## REDLAND OAKS

REDLAND - BULVERDE JOINT VENTURE  
MASTER PLAN  
SAN ANTONIO, TEXAS

INFORMATION SHEET FOR  
PRELIMINARY OVERALL AREA DEVELOPMENT PLAN  
(P.O.A.D.P.)

RE: Redland Oaks Development Plan #207

**FIELD CHANGE  
NO. 4**

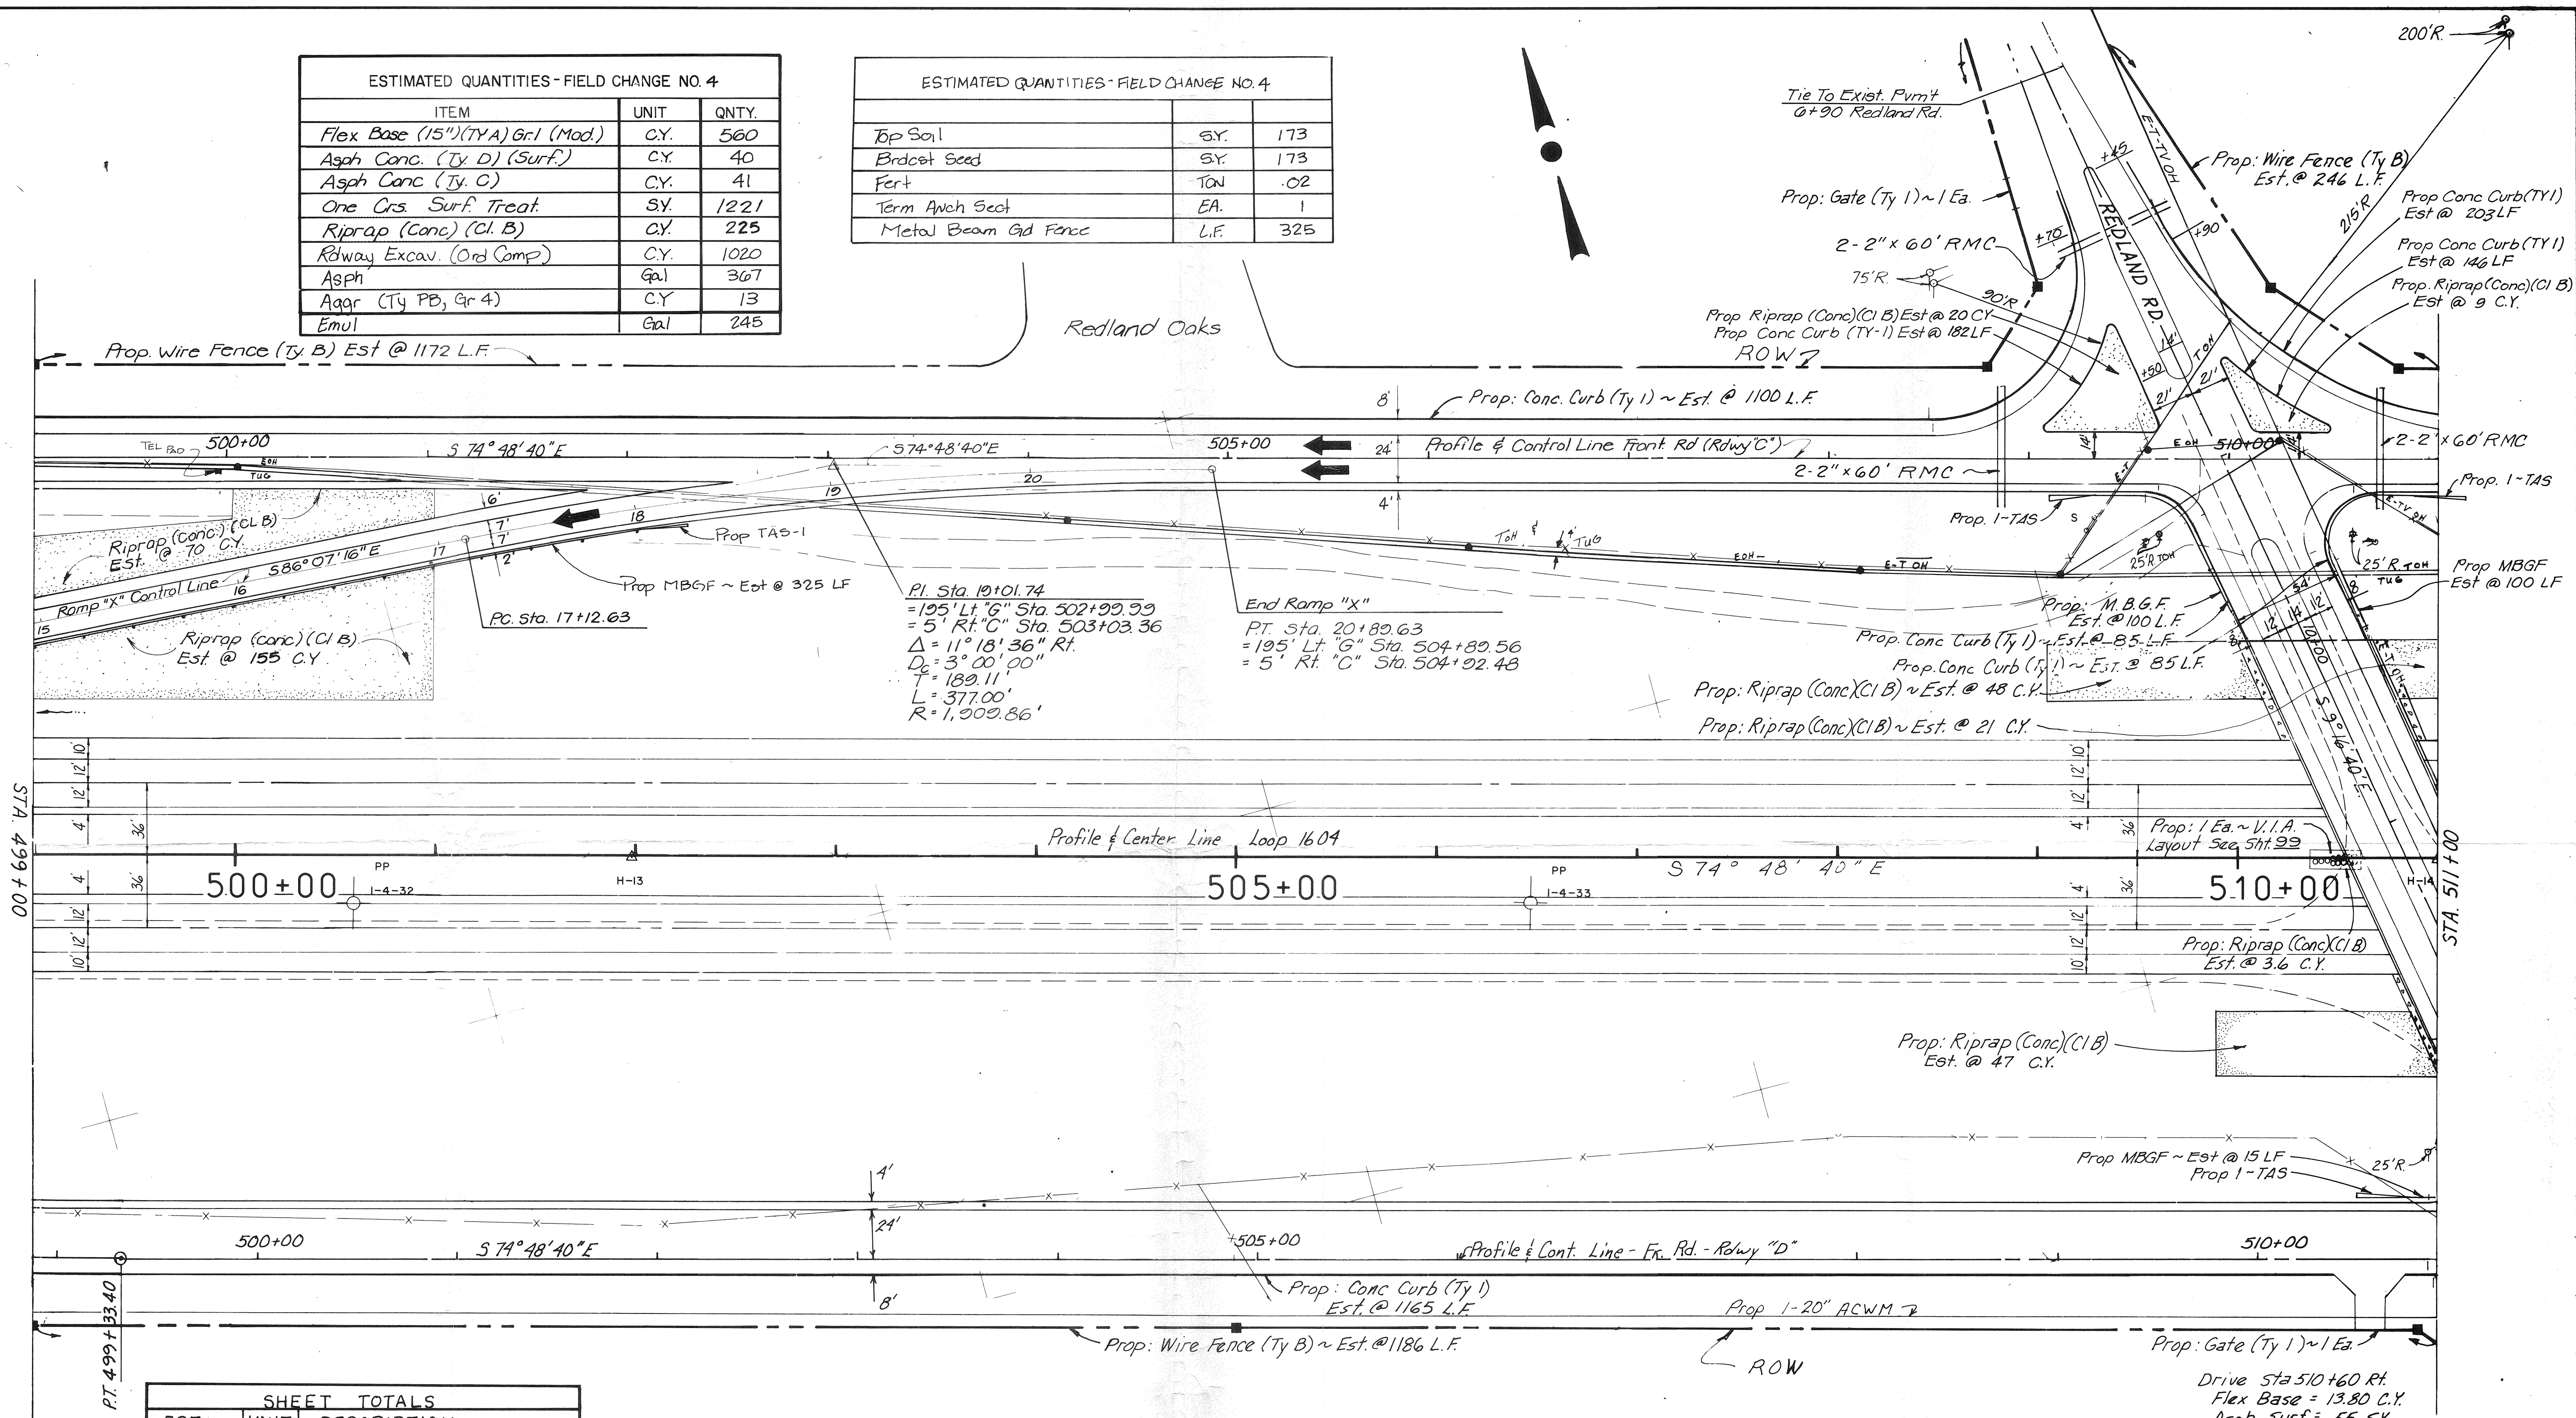
Attached is a copy of the drawings showing the proposed westbound entrance ramp which we plan on constructing as soon as possible. This construction will conform with the requirements of the right-of-way dedication deed recorded in Volume 3753, Page 718, of the Official Public Records of Real Property of Bexar County. We used an unapproved subdivision plat of the Redland Oaks subdivision supplied to us by your office to locate the ramp. The intersection location as described on the plat, should not be jeopardized.

We also researched the driveway access permit for Redland Oaks Drive and have found that it is still valid. No other permits are needed by the developer to construct the intersection. We request that you send us a copy of the plat when it is approved. We would like to verify that the intersection is not in conflict with our "no access zone" as described in our design manual. Let me emphasize the point that we maximized our location of the ramp to the east and any relocation of the intersection to the west would place it in conflict with our "no access zone". This would automatically invalidate the driveway permit.

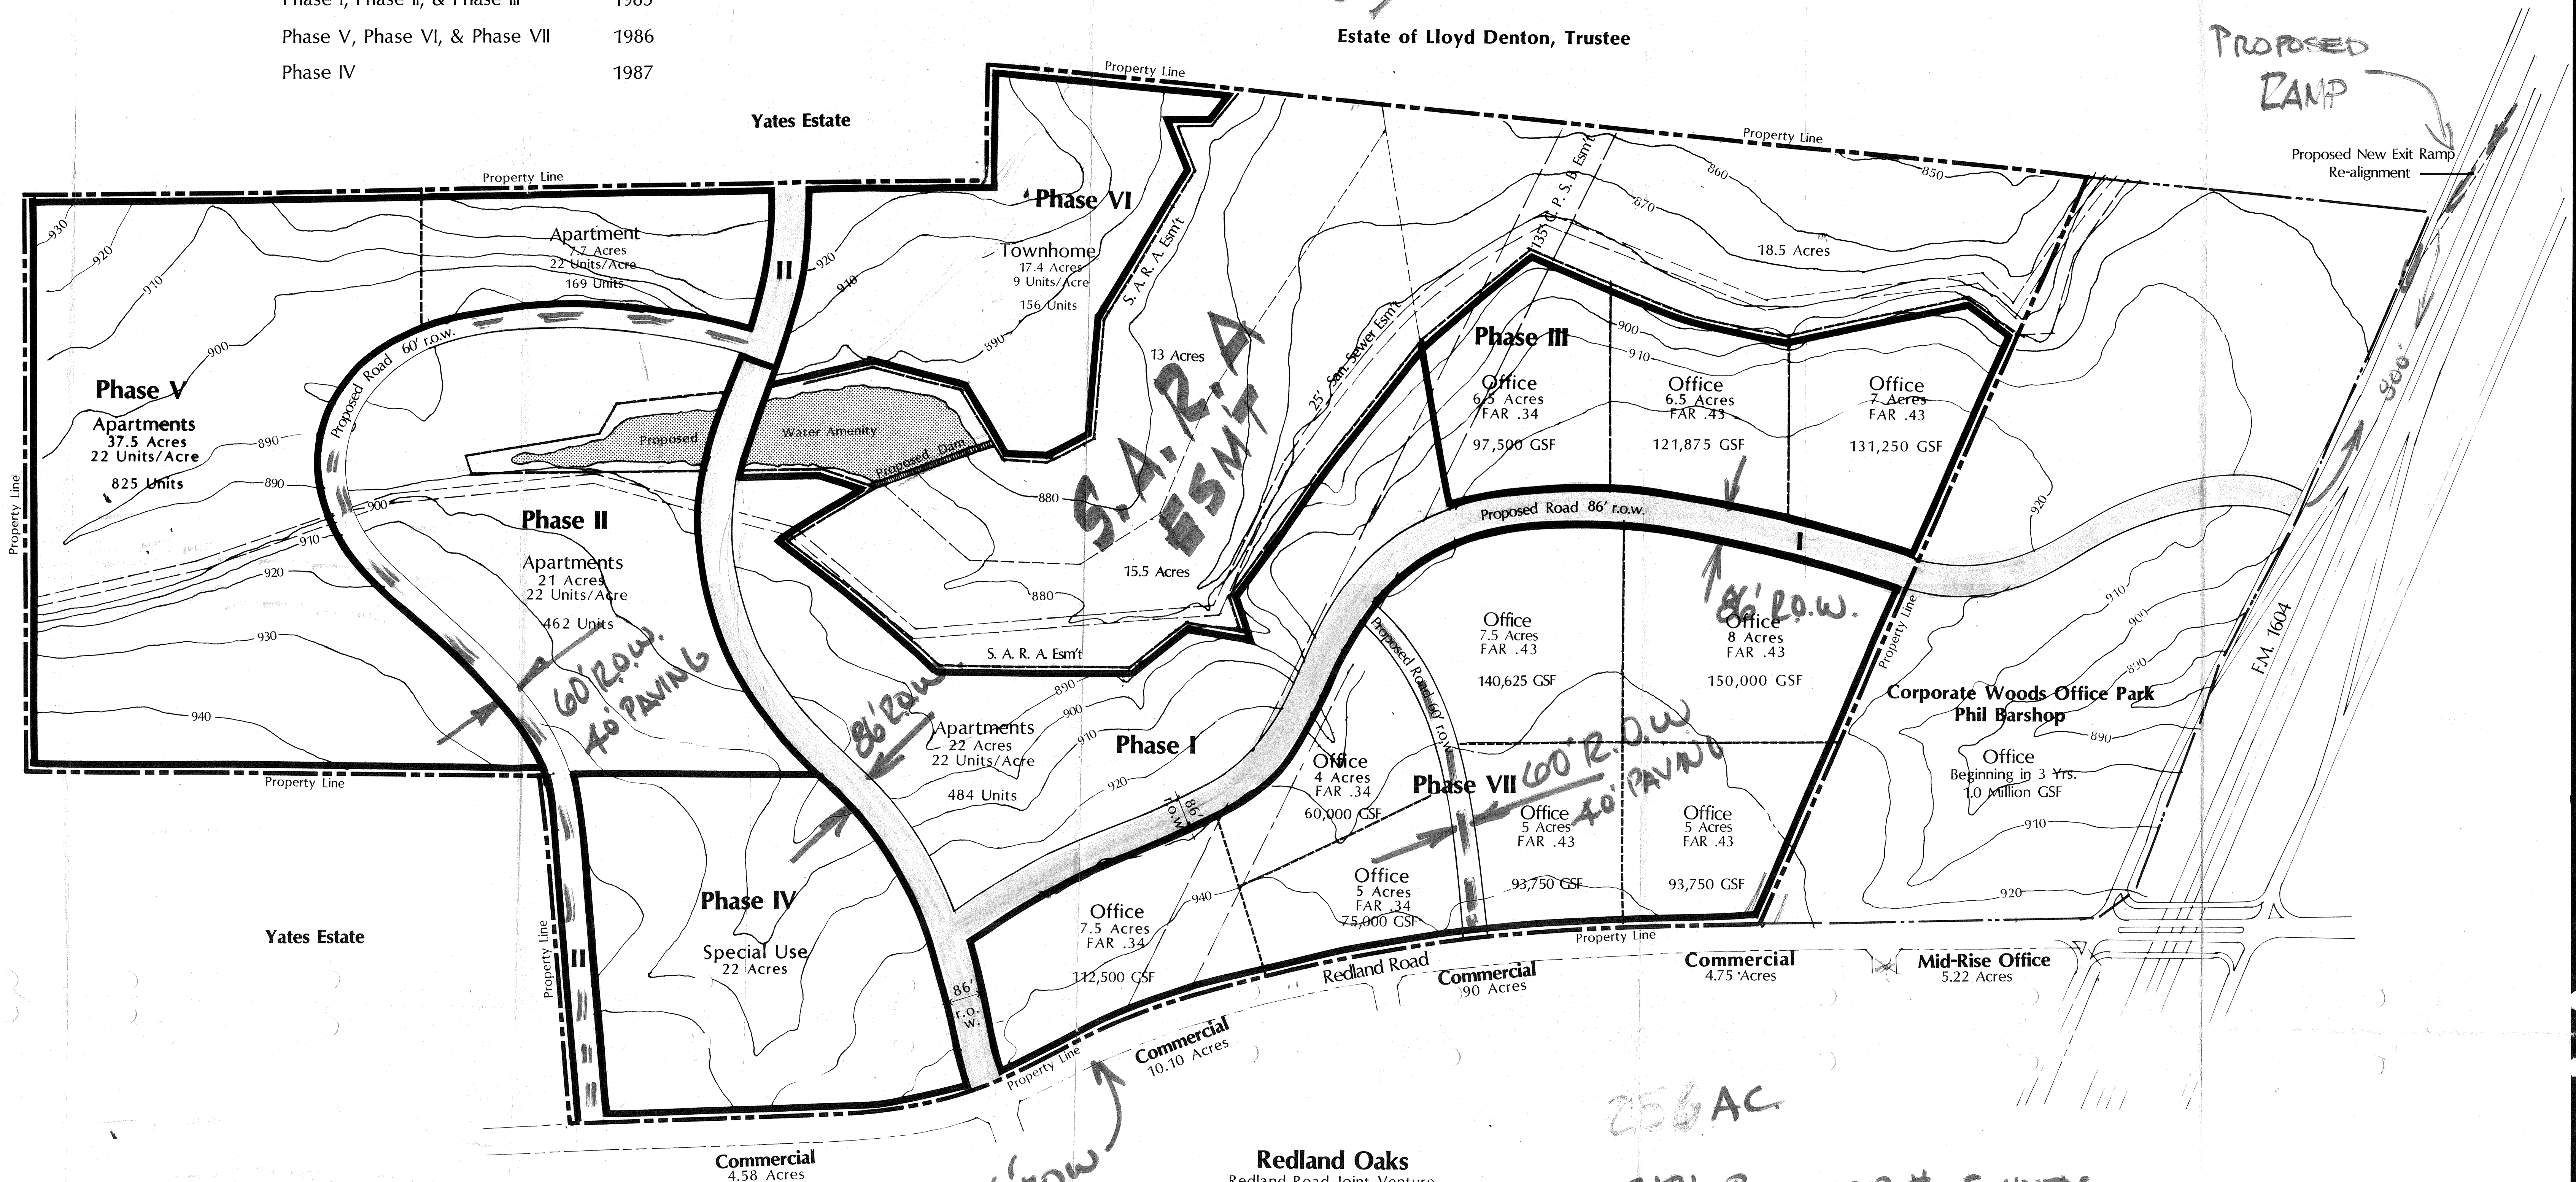
(X) Comments: This is to advise you that the POADP bordering the southern property line of your development project has been amended to delete the 60' R.O.W. referenced in our comments dated January 30, 1985.  
In view of this, staff offers no objections to your plan as submitted.

It is noted that the POADP bordering the southern property line of your scheme is not consistent with your proposal. The development plan (Corporate Woods Office Park) calls for a 60' R.O.W. linking the north-south 86' facility with Redland Road. In addition, the street as depicted encroaches into the Pargon property. Taking this into account, it is recommended that planning efforts be coordinated with neighboring property owners. Once this matter has been resolved, please make the necessary changes to the POADP and resubmit the plan for staff review.
